Project: IEEE P802.15 Study Group for Wireless Personal Area Networks (WPANs)

- Submission Title:** PSSS proposal – Parallel reuse of 2.4 GHz PHY for the sub-1-GHz bands
- Date Submitted:** 14th April 2005
- Source:** Andreas Wolf, DWA Wireless GmbH and Hans van Leeuwen, Integration
DWA Wireless GmbH, Germany
Tel.: +49 (0)700 965 32 637 aw@dw-a.com

- Integration, USA**
Tel: +1 858 344 5120 hvl@highstream.net
- Re:** PSSS mode for more even chiprates, simpler filter, and 250 kbit/s in 868 MHz
- Abstract:** Ballot comments received indicated interest in the TG4b task group to modify the PSSS mode for 868 MHz to have the same 250 kbit/s bitrate as the 2.4 GHz and the PSSS 915 Mhz modes.

- Purpose:** Response to ballot comments to discuss potential modification of PSSS draft specification
- Notice:** This document has been prepared to assist the IEEE P802.15. It is offered as a basis for discussion and is not binding on the contributing individual(s) or organization(s). The material in this document is subject to change in form and content after further study. The contributor(s) reserve(s) the right to add, amend or withdraw material contained herein.

No modification of the basic PSSS model: PSSS 250-400 868 MHz – BPSK/ASK (20/32 bit/s/Hz)

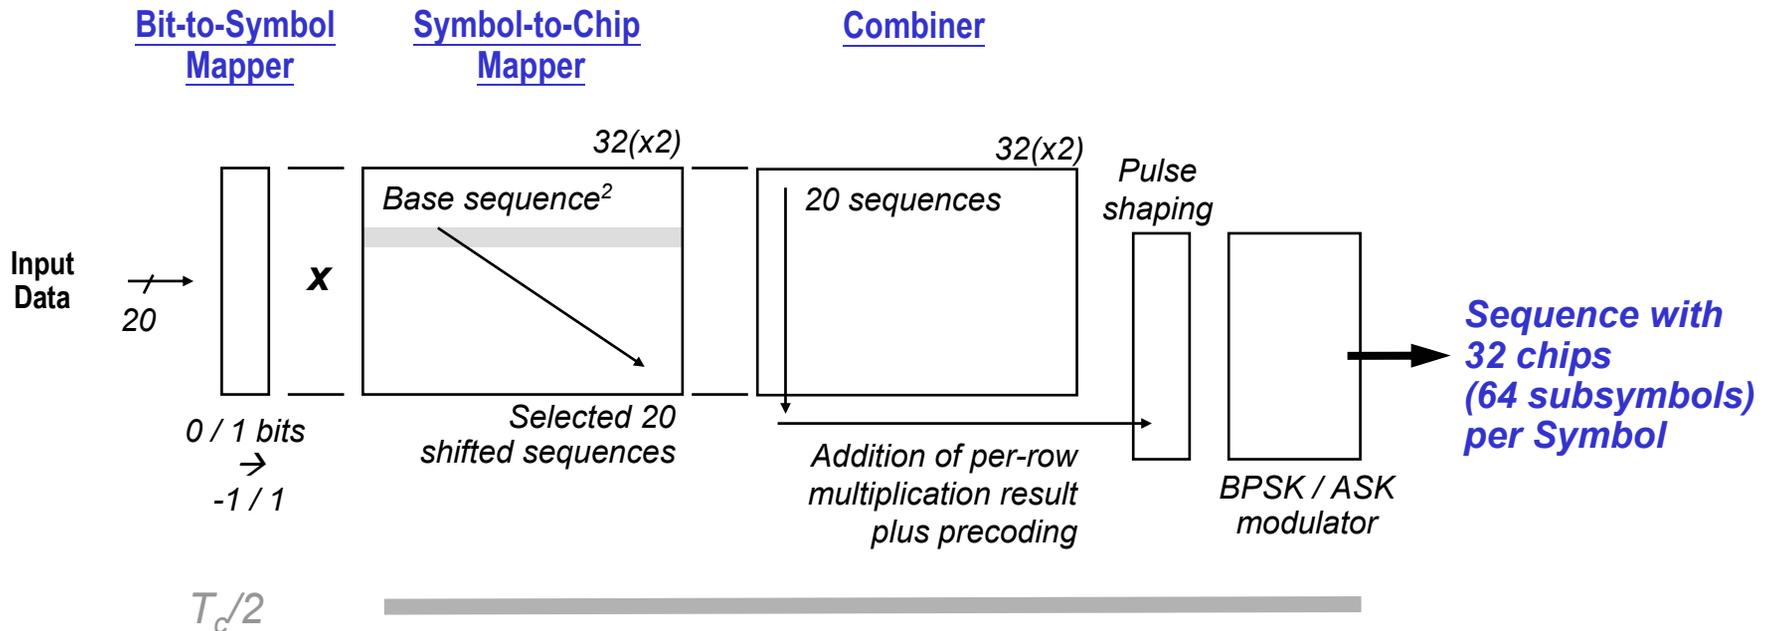
Shifting of sequences by 3 instead of 4 subchips enables addition of sequences to achieve 250 kbit/s and 400 kcps

- 2 sub-chips per chip – basic chip rate of coding scheme is unchanged
- Addition per sub-chip for multivalue encoding – no other changes of PSSS model

- **No increase of Tx complexity in real-world implementation –**
 - Oversampling used for baseband filtering to achieve PSD compliance anyhow
 - No change in number of chips per symbol – no increase in coding table sizes
- **Simpler baseband filter sufficient due to lower chiprate**
- **No change in Rx processing required**

Proposed Preamble

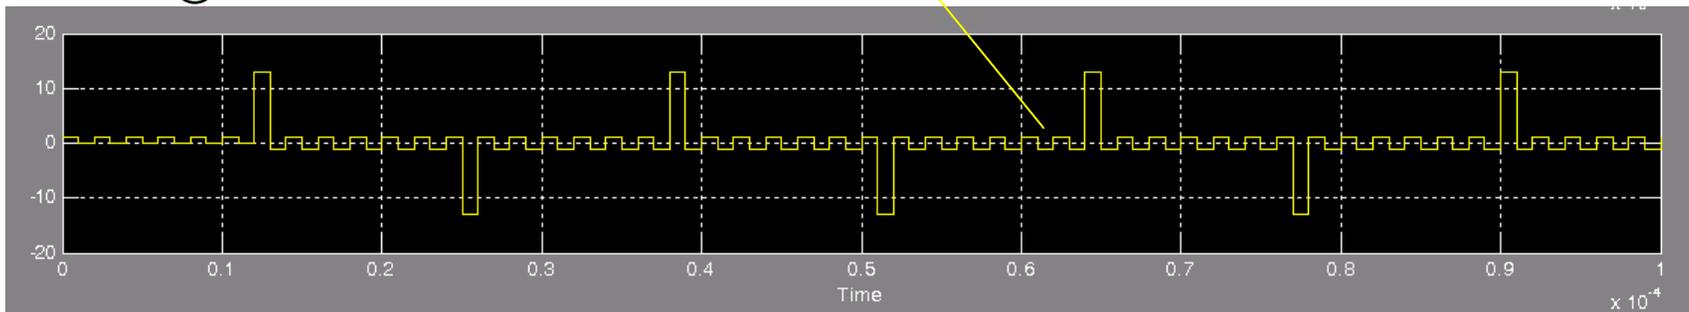
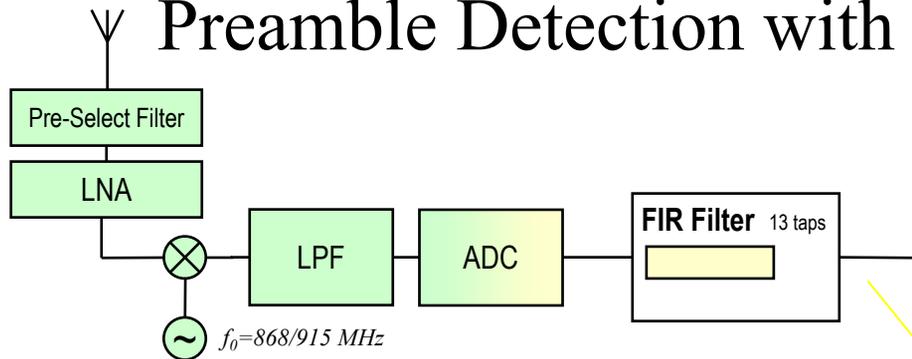
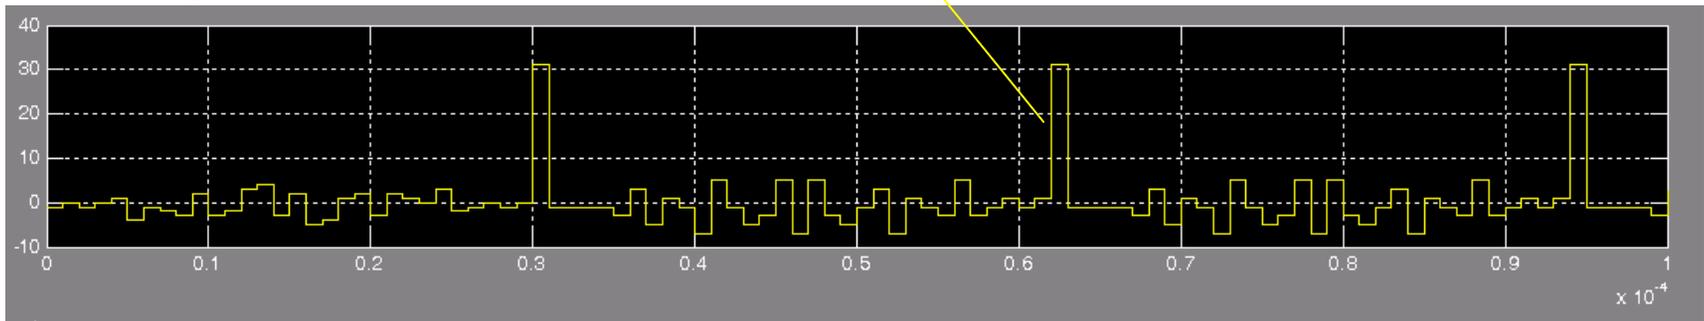
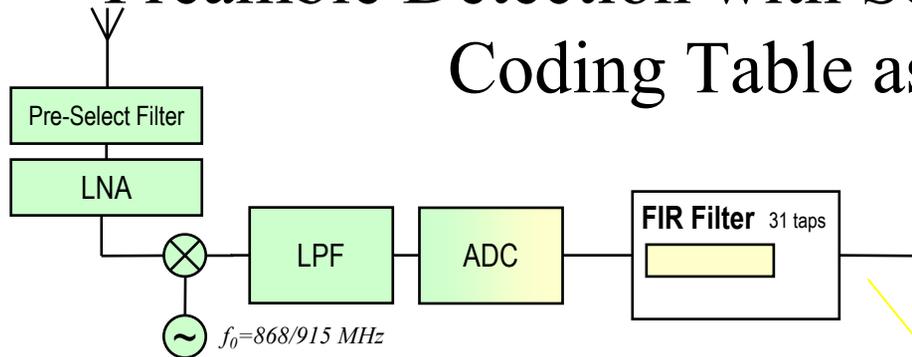
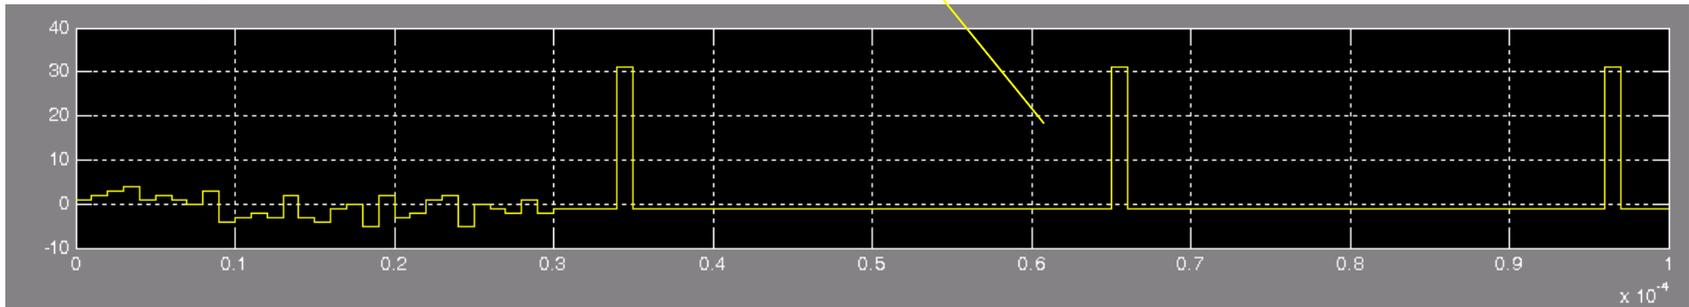
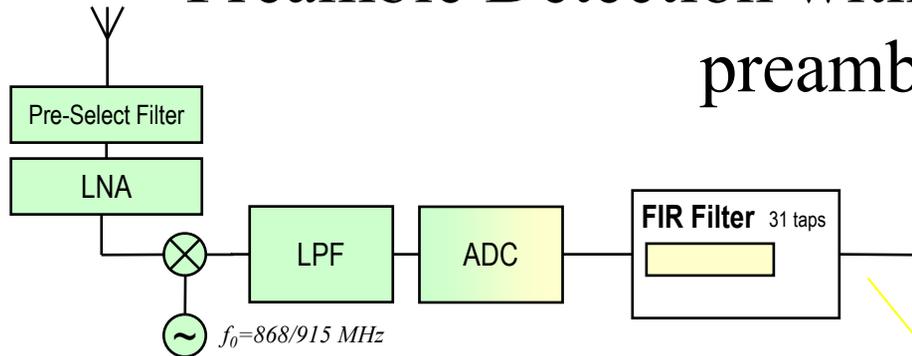
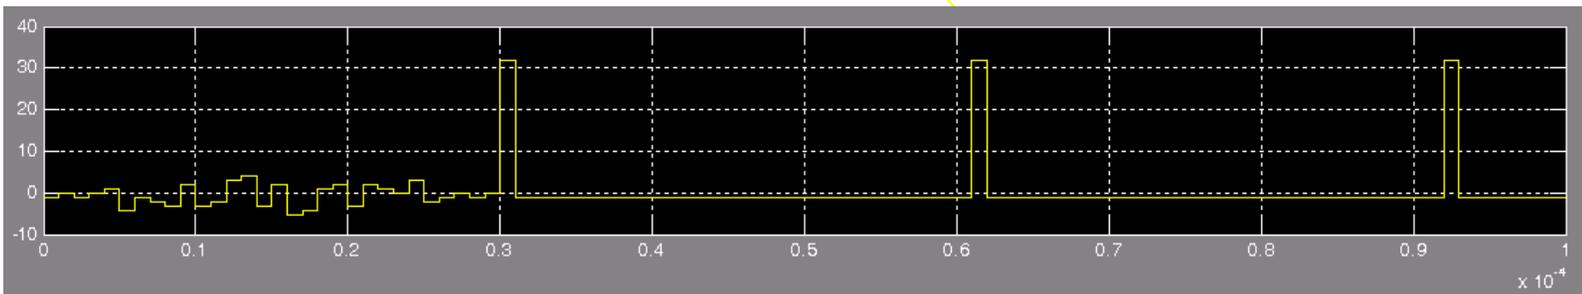
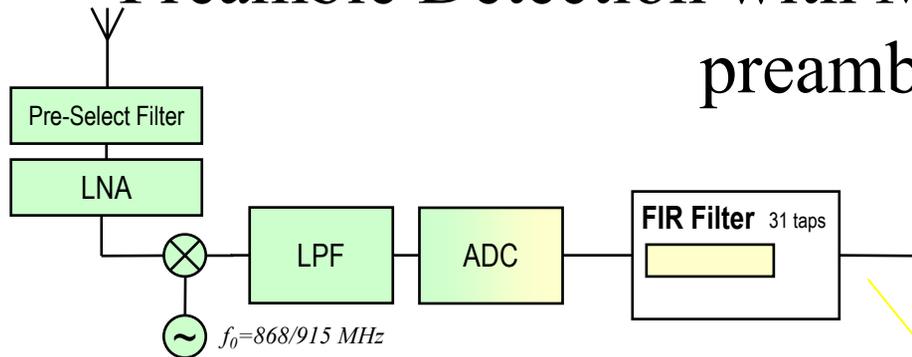
- When detecting the current barker code based preamble with FIR filter, the signal coming out of the FIR filter has side slopes limited to +/- 1.
- Advantages:
 - It is DC free
- Disadvantages:
 - Sides slopes causes a mismatch of the energy maximum detection for multipath fading channels.
 - Two FIR filters needed, one for preamble detection (13 chip barker code), one for PSSS decoding (31 chip m-sequence).

- When detecting the preamble, base on repeated sequence 0 with FIR filter, the signal coming out of the FIR filter has side slopes limited to +5/-6.
- Advantages:
 - Use of just one FIR filter or correlator for preamble detection and PSSS decoding.
 - 32 chip long preamble code.
 - DC free
- Disadvantages:
 - Sides slopes causes a mismatch of the energy maximum detection for multipath fading channels.

- When detecting the preamble, based on repeated m-sequence c_0 with FIR filter, the signal coming out of the FIR filter has no side slopes, when the first m-sequence c_0 has passed the FIR filter.
- Advantages:
 - Use of just one FIR filter or correlator for preamble detection and PSSS decoding.
 - No side slopes.
 - Optimal maxima detection for multipath fading channels possible.
- Disadvantages:
 - Not DC free.
 - Length of 31 chips instead of 32 chips

- When detecting the preamble, based on repeated m-sequence c_{0dc_free} with FIR filter, the signal coming out of the FIR filter has no side slopes, when the first m-sequence c_{0dc_free} has passed the FIR filter.
- Advantages:
 - Use of just one FIR filter or correlator for preamble detection and PSSS decoding.
 - No side slopes.
 - DC free.
 - Optimal maxima detection for multipath fading channels possible.
- Disadvantages:
 - 31 chip length instead of 32 chips as for the PSSS codes

- We propose to use a preamble with repeated Sequence 0 or m-sequence c_0/c_{0dc_free} for lowest design complexity and highest performance.
- If length of 32 chips is needed for preamble code the usage of Sequence 0 is the best solution.

- The sequence 0 or m-sequence c_0/c_{0dc_free} should be repeated 6 or 7 times for getting nearly same length than the original Barker code base sequence.

PER Performance PSSS 250-400 868 MHz (BPSK/ASK) – Discrete Exponential Channel, 250ns RMS Delay Spread

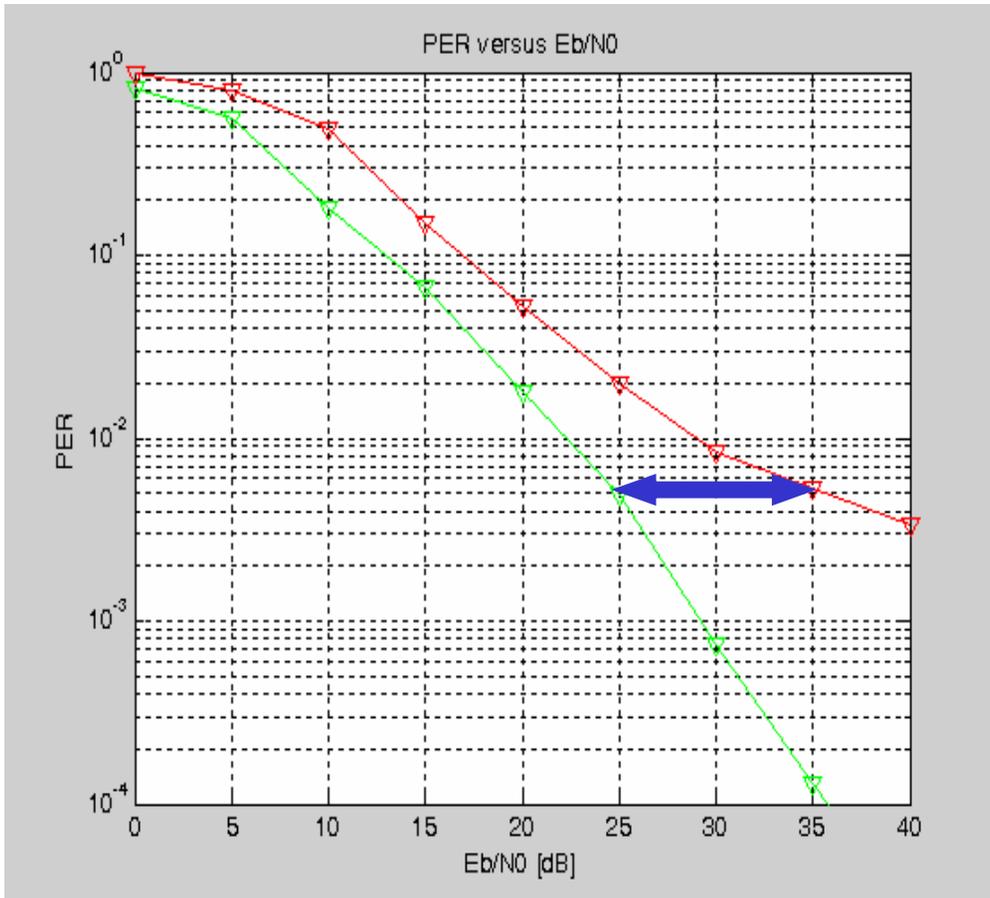
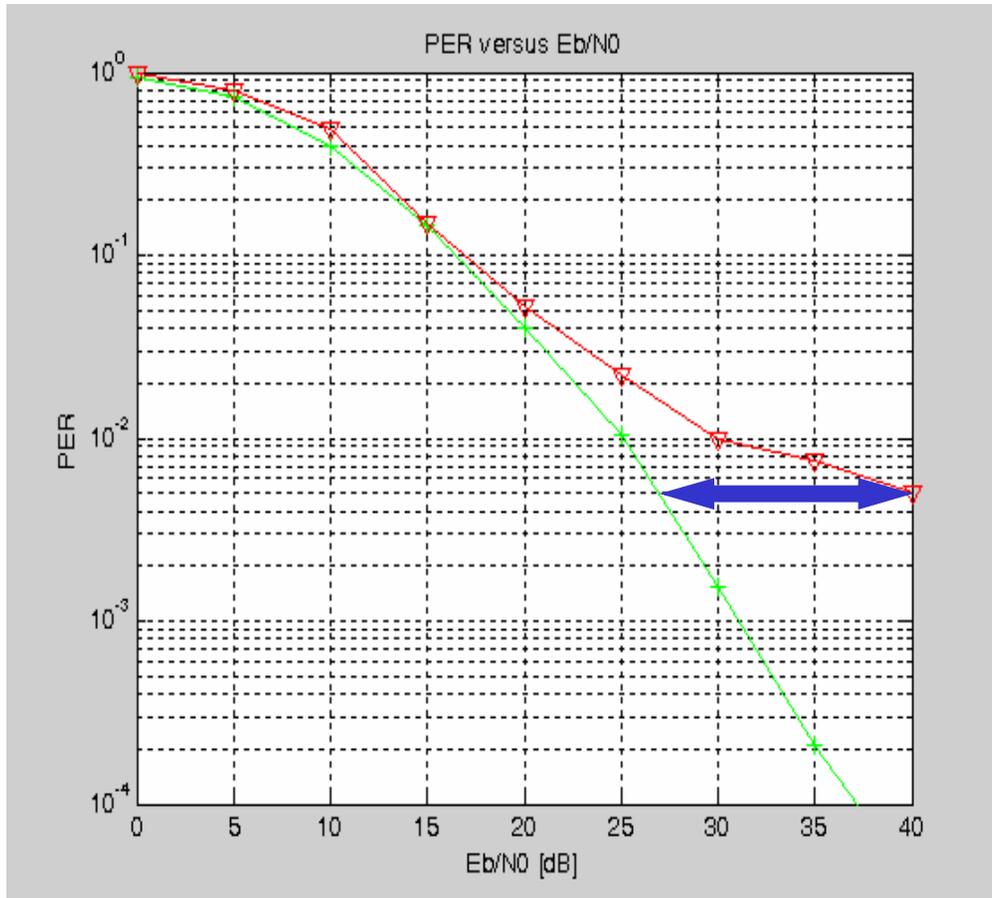
Comparison to PSSS 206-440 868 MHz

- No visible degradation of performance
